2020/3405/P and 2020/3388/L

14 Provost Road

Delegated Report		Analysis sheet		Expiry Date:	ate: 24/09/2020		
(Members Briefing)		N/A		Consultation Expiry Date:	11/10/2020		
Officer			Application N	umber(s)			
Jaspreet Chana			i) 2020/3405/P ii) 2020/3388/L				
Application Address		Drawing Numbers					
14 Provost Road London NW3 4ST			Please refer to draft decision notice				
PO 3/4 Area To	eam Signatur	e C&UD	Authorised Of	ficer Signature			
Proposal(s)

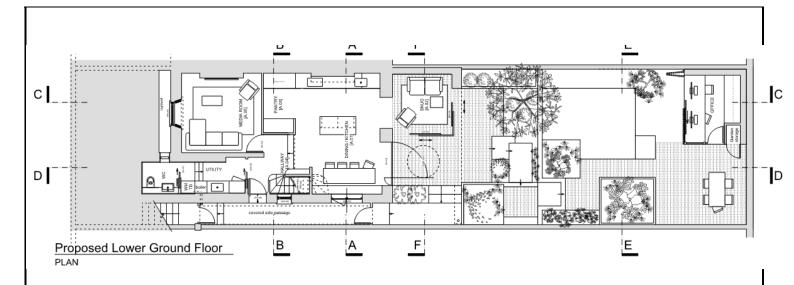
1.4 Revisions – During the process of the application the following revisions have been received following the

objections received:

- The removal of the pergola; enlargement of the nib to the rear wall at lower ground level and no alterations proposed to the windows throughout the house are included within this application. The proposed dormer windows have also been reduced in size from a proposed 4m width to 3.7m (street side dormer) and 3.7m wide to 3.6m wide (rear side dormer) and are now 1.7m in height. The glazing has been updated so the windows are now made of 4 panes rather than 9 to be consistent with the majority of dormers along the street and the proposed location of the rooflights have also been amended.
